# Riverside Park

## Master Plan

Re: Riverside Park Plan  
(Baltimore City Landmark Park-City-owned Park)

On May 11, 2010, the Baltimore City Commission for Historical & Architectural Preservation (CHAP) considered the Department of Recreation and Parks presentation of a Master Plan for Riverside Park. This historically significant site is a designated Baltimore City Landmark.

# EXHIBIT A: ILLUSTRATIVE MASTER PLAN

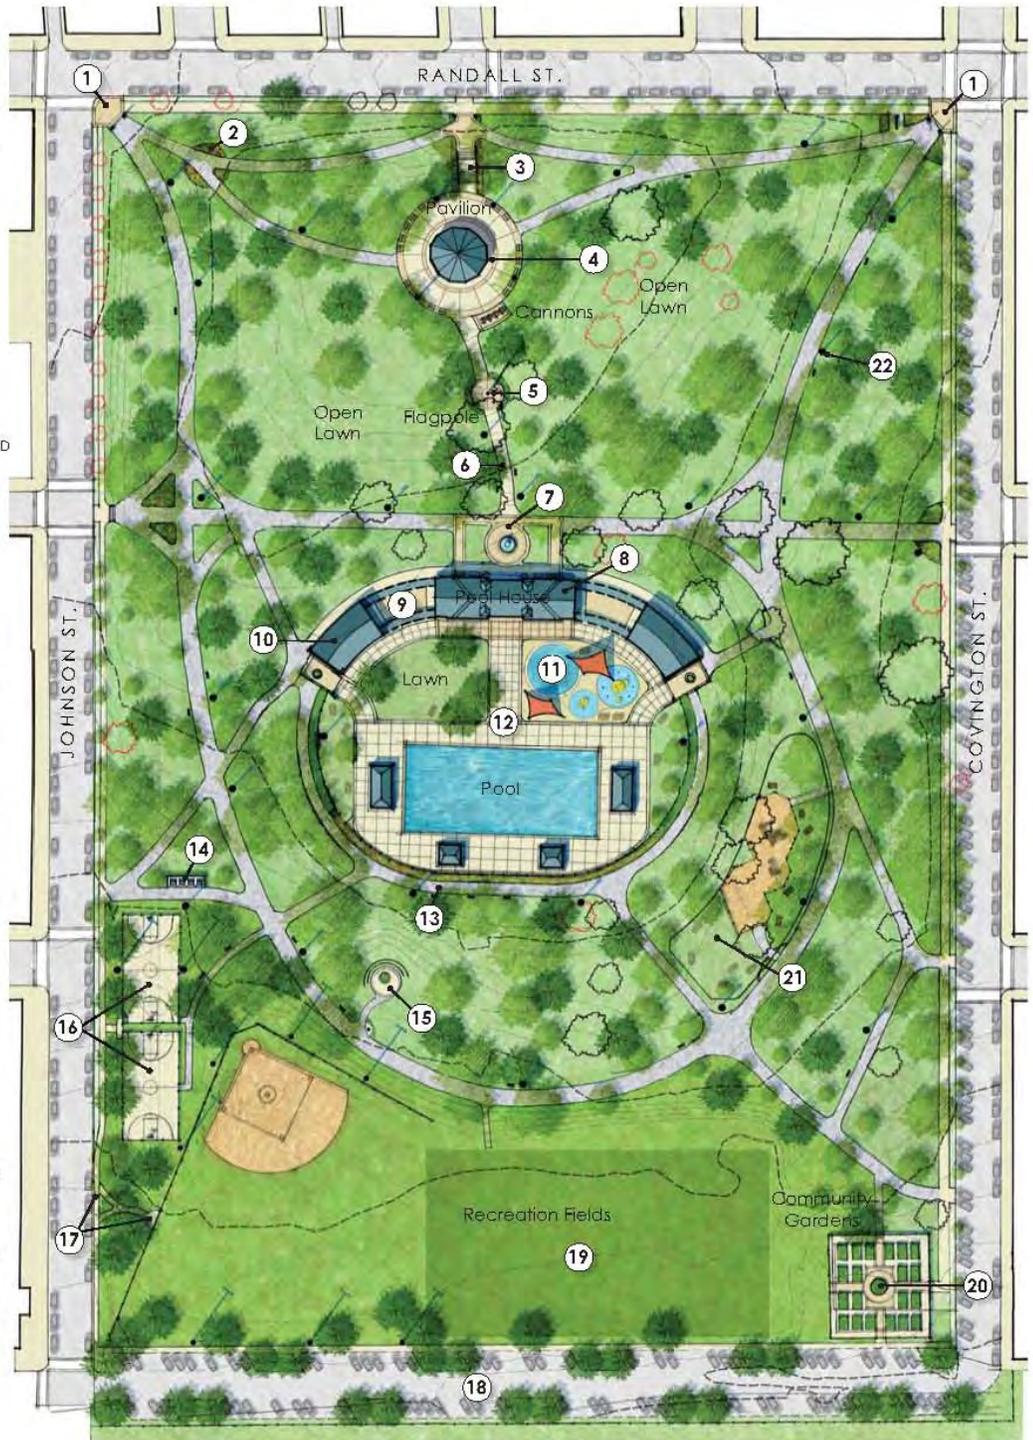
The Master plan process for Riverside Park was fast tracked in order to be able to implement many of the improvements prior to the Bicentennial of the War of 1812. The Friends of Riverside Park, Department of Recreation and Parks, and CHAP have been involved with preliminary planning for the Bicentennial of the War of 1812. The Master Plan embraces the conclusions of the 2007 Landmark designation report and addresses the preservation issues with treatments that clearly meet our guidelines. Please refer to Exhibit A (page 8) of the Master Plan.

The following summary details the suggested master plan changes and cites CHAP's guidelines for Historic Landscapes (Chapter 10 of the *Baltimore City Historic Preservation Procedures and Design Guidelines*):

1. Install accent paving at corner entrances. This action meets CHAP guidelines "maintain existing walkway within parks in good repair (Public parks page 56)," and "Identify, retain and preserve historic spatial organization and land patterns as they have evolved over time (site context page 57)."

2. Install community accent gardens. This action meets CHAP guidelines under Trees and other plantings (page 60).
3. Install accent paving at main entrance and low planting at existing stair edge. These actions meet guidelines "maintain existing walkway within parks in good repair (Public parks page 56)," and "Identify, retain and preserve historic spatial organization and land patterns as they have evolved over time (site context page 57)," and guidelines under "Views."

5. Install accent paving and low planting around the flagpole. The Flagpole is a historic feature; however, the paving around it is not. Accent paving will highlight this feature. This action meets the guidelines as cited above.

7. Construct an entry plaza with a fountain, ornamental trees, and low planting with seasonal interest. This action meets our guidelines Chapter 10, Monuments and Public Art, "site new monuments and public art to complement the existing site design. New monuments and public art should not disrupt the existing scale, landforms, or patterns of spatial organization."

8. Renovate Existing Pool house. New layout to include community office and storage. The existing pool house was determined in 2007 to be extremely deteriorated; therefore, nonhistoric. The renovation plans, however, do meet the guidelines Chapter 10, Accessory Structures "Replace accessory structures only if they are beyond repair. Reconstruct missing accessory structures only where there is sufficient historical documentation. Replacement accessory structures should be of similar siting, scale, proportion, materials, and color to the original.

9. Reduce Width of existing path surrounding pool area and introduce plant buffer between path edge and pool fence meets guidelines Chapter 10, Public Parks.

10. The rest of the plan calls for the renovation of the southern portion of the park, which was identified as the active-recreation portion of the park. The plan recommends the installation of portable bathrooms, amphitheater, water fountain, entrance along Johnson Street, and a community garden. The plan also calls for the removal of the recreation storage shed and maintenance building. These actions meet CHAP Guidelines Chapter 10, Public Parks.

The Commissioners considered the application materials, the presentation, the staff report and testimony presented at the hearing. They moved to accept the recommendation of staff and grant approval of the Master Plan with implementation of the plan to be approved at the staff level.
